**RE: Overture Senior Active Adult  
6410 Palomas Ave NE  
Grading and Drainage Plan  
Engineer's Stamp Date: 10/17/18  
Hydrology File: D18D056A**

# **DRAINAGE MANAGEMENT PLAN**

## **Overture Senior Active Adult**

**RE: OVERTURE SENIOR ACTIVE ADULT  
GRADING AND DRAINAGE (FILE: D18D056A)**

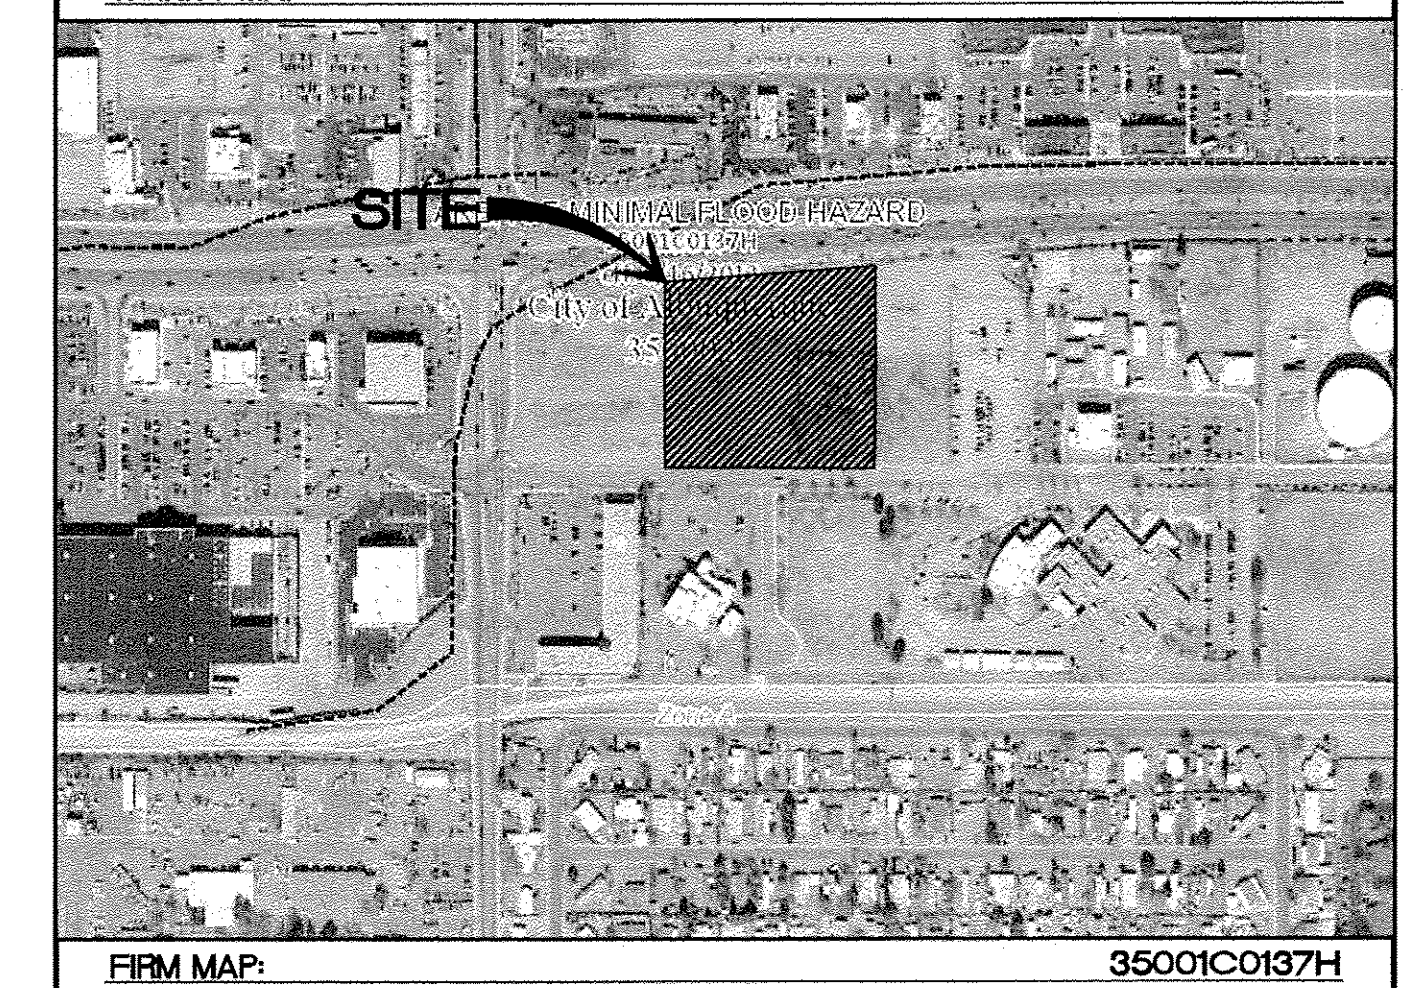
2. Please provide the FIRM Map's effective date.

3. Please provide the benchmark information for the survey contour information provided.

5. Please add a note requesting a waiver for the first flush volume requirement. Also add a note stating, "The required first flush volume for the 142,764.70 SF of impervious cover is 4,045 CF."

**RESPONSE: The FIRM Map's effective date is 08/16/2012. We added this notation to Sheet C2.**

**RESPONSE: We added the benchmark information to Sheet C2 (located in Paseo Del Norte sidewalk, near northeasterly property corner).**

**RESPONSE: We have added a note indicating the first flush requirement and formally requesting a waiver to allow in-lieu fee payment onto Sheet C2.**

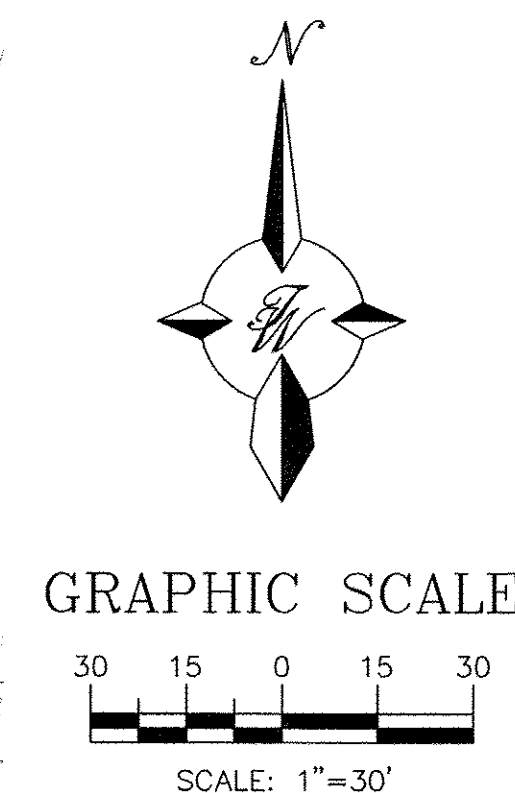
4. Please provide a section of the proposed retaining wall along Paseo del Norte near the Northwest corner of the site and a section of the proposed retaining wall along the western property line.

**RESPONSE: The section views requested are now included on an added Sheet C2.1 for clarity.**
